PROTERRA

TECHNICAL SERVICE BULLETIN

ISSUE DATE:	10-13-2020
SERVICE BULLETIN SUBJECT:	Lower Rear Access Door Opening Angle and LV Battery Tray Retrofit
VINs or MODELS AFFECTED:	Service Specified Buses
COMPLETE BY:	Next Service Opportunity
SERVICE BULLETIN #:	SC-20-145
Labor Operation Code:	N/A

LOWER REAR ACCESS DOOR OPENING ANGLE AND LV BATTERY TRAY RETROFIT

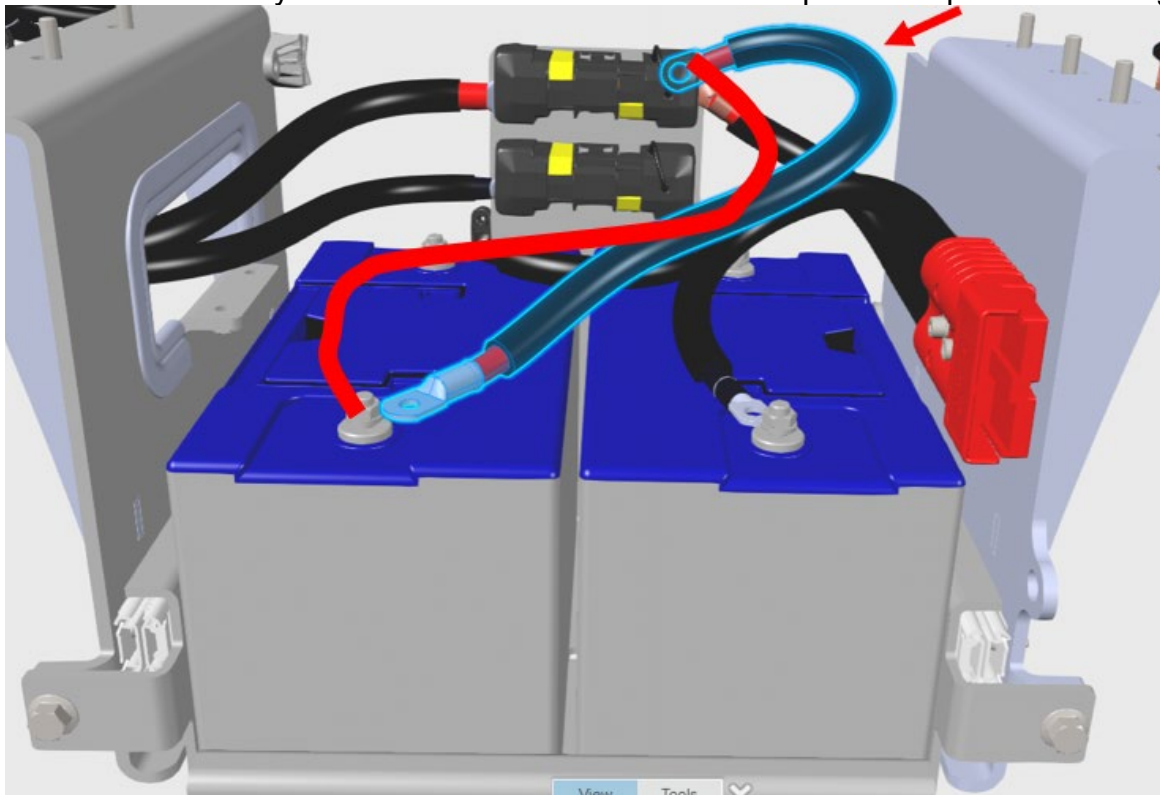
39. Working inside the Curbside hatch, access the low voltage batteries.
40. Using an 13mm Ratchet/Socket, reroute the Cable (EPWR 109) shown by the red arrow. The new routing is shown by the curved red line. The cable should enter the fuse panel from the bottom as shown by the red line and be routed in an "S" pattern to prevent chaffing.

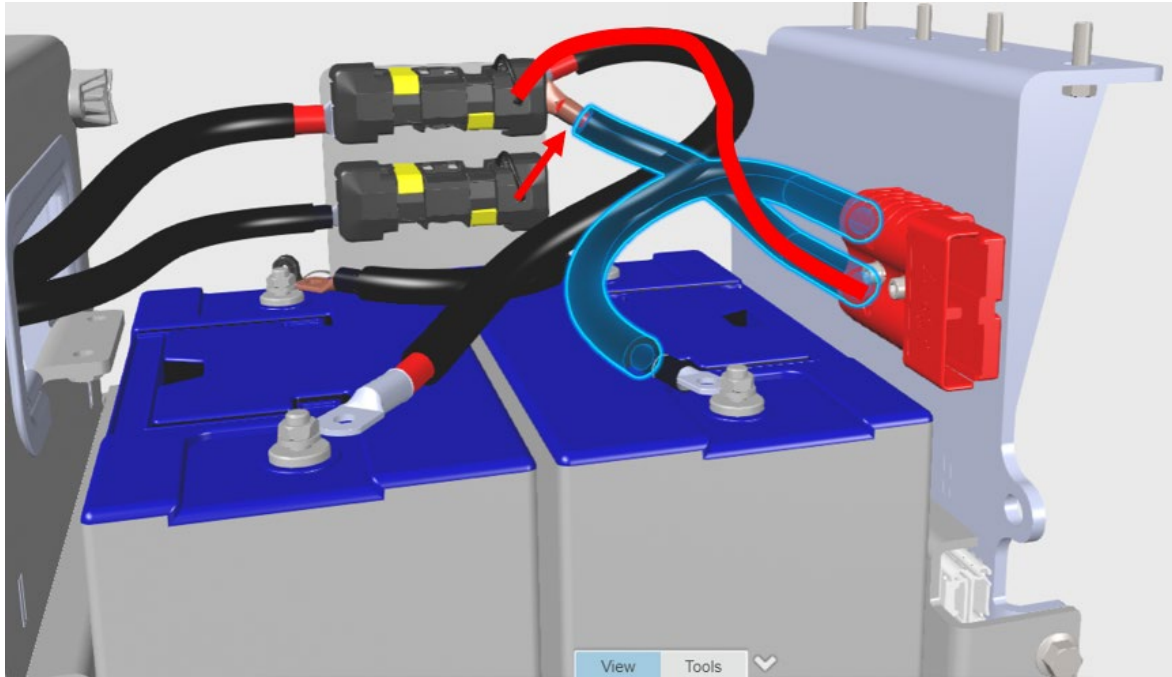
41. Using an 13mm Ratchet/Socket, reroute the cable shown by the red arrow. The new routing is shown by the curved red line. The cable should enter the fuse panel from the top as shown by the red line.

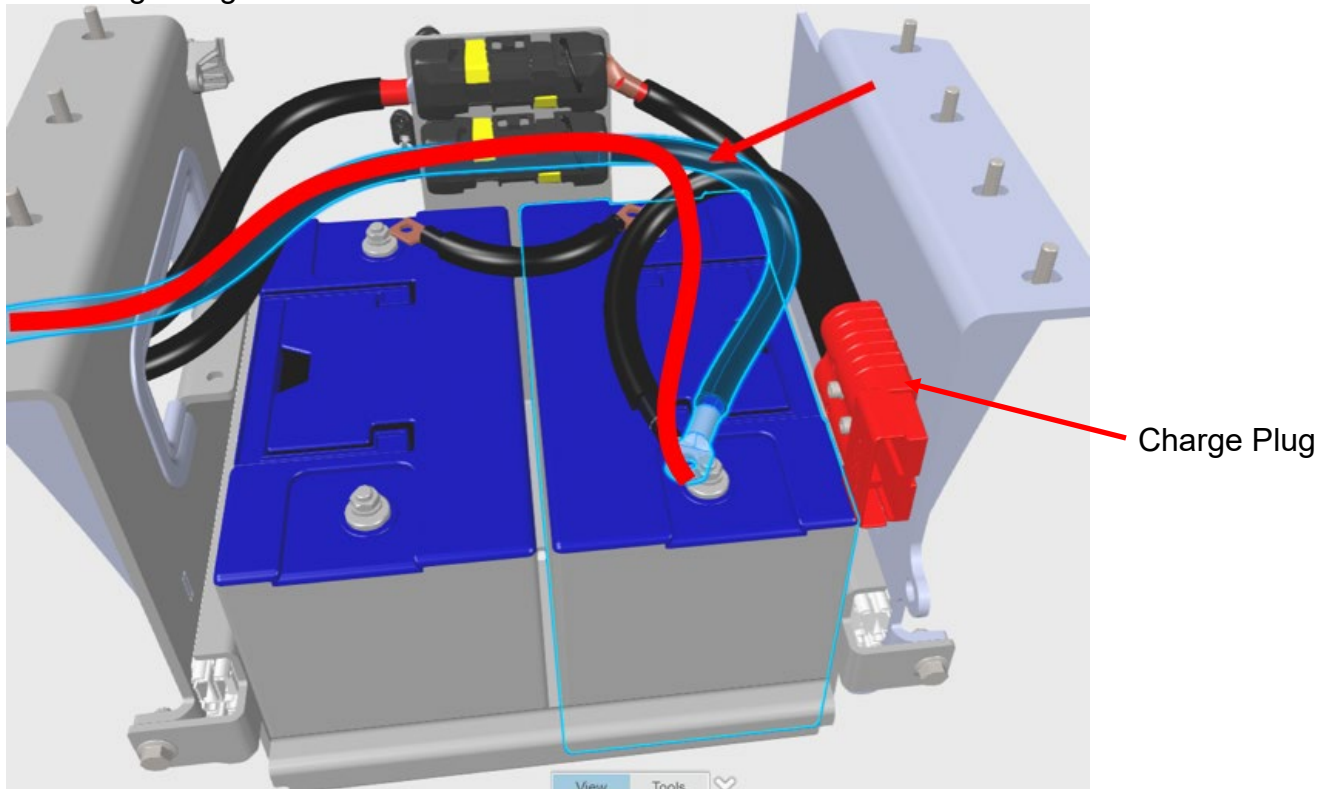
43. Using an 13mm Ratchet/Socket, reroute the Cable (EPWR 106) shown by the red arrow. The new routing is shown by the curved red line. The original route of this cable should be swapped with the Negative Cable from the Charge Plug and straightened so that it doesn't chaff against the battery box when it is slid from the hatch. The negative cable is on the top of the Charge Plug.

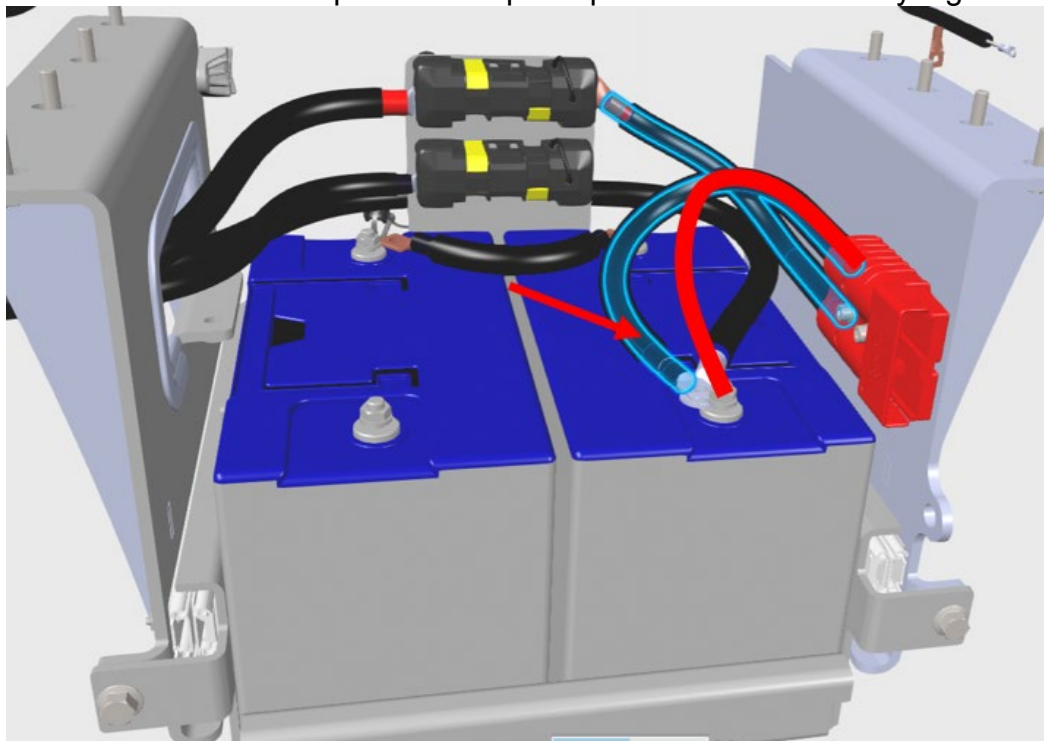
44. Using an 13mm Ratchet/Socket, reroute the cable shown by the red arrow. This is the negative cable from the Charge Plug. The new routing is shown by the curved red line. Note that the cable from the previous step swaps sides on the battery lug.

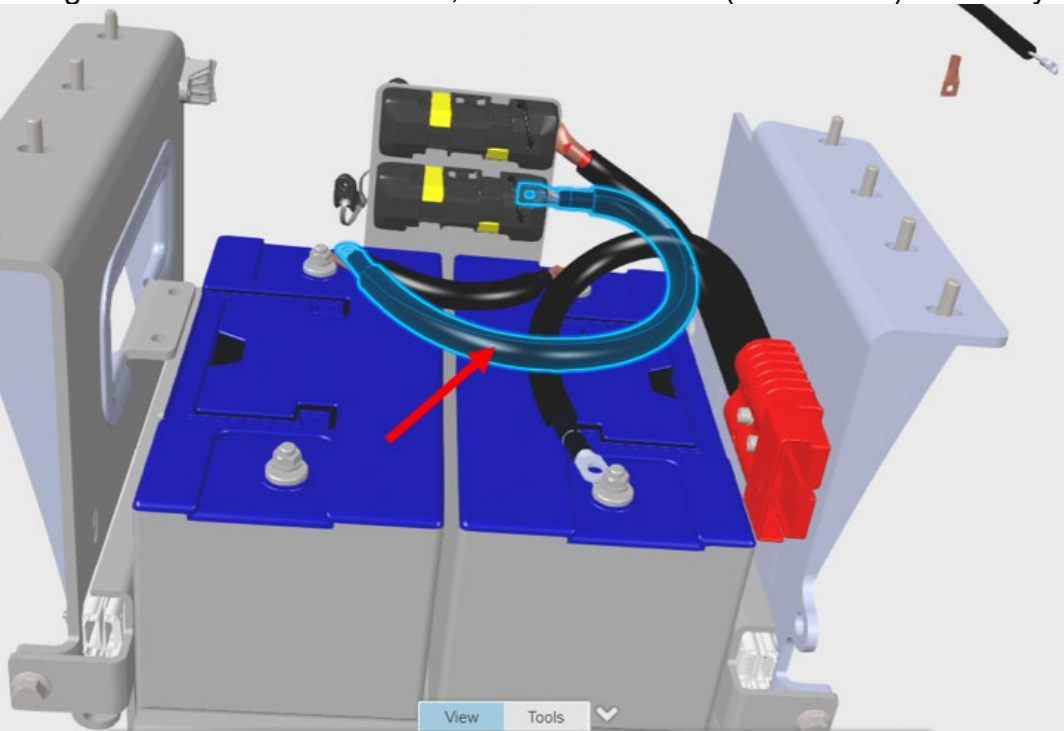
46. Using an 13mm Ratchet/Socket, reroute the Cable (EPWR 108) shown by the red arrow.

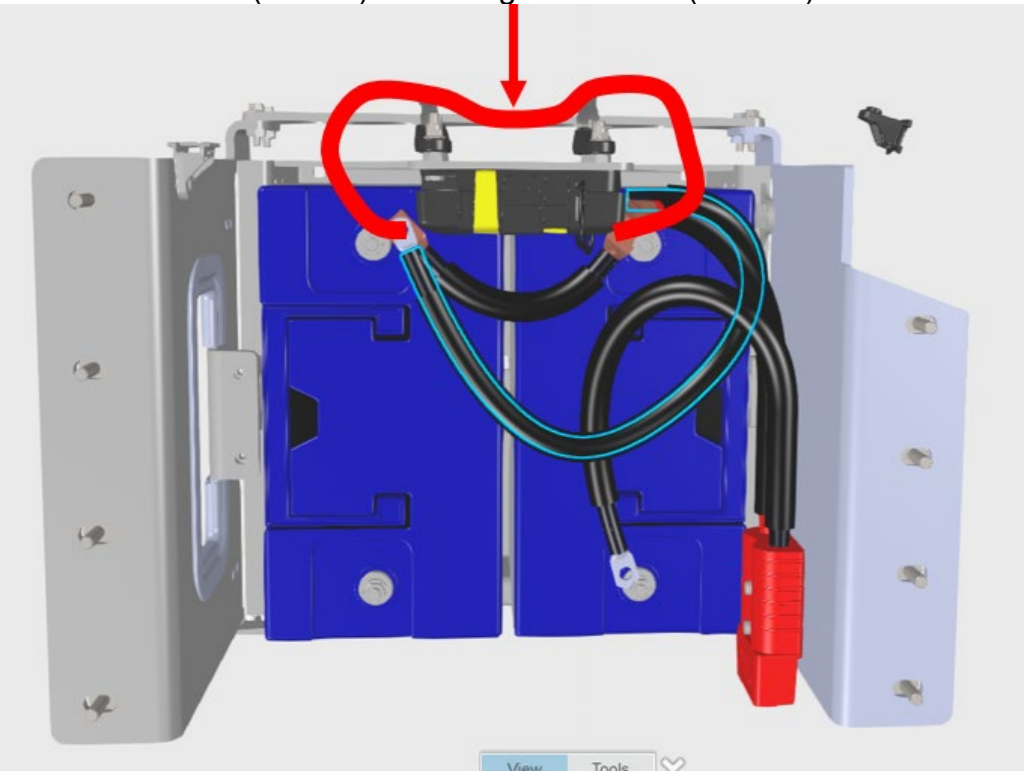
47. The new routing is shown in the following illustration. The Cable (EPWR 108) should be secured to Cable (EPWR) 106 using Cable Ties (012138).
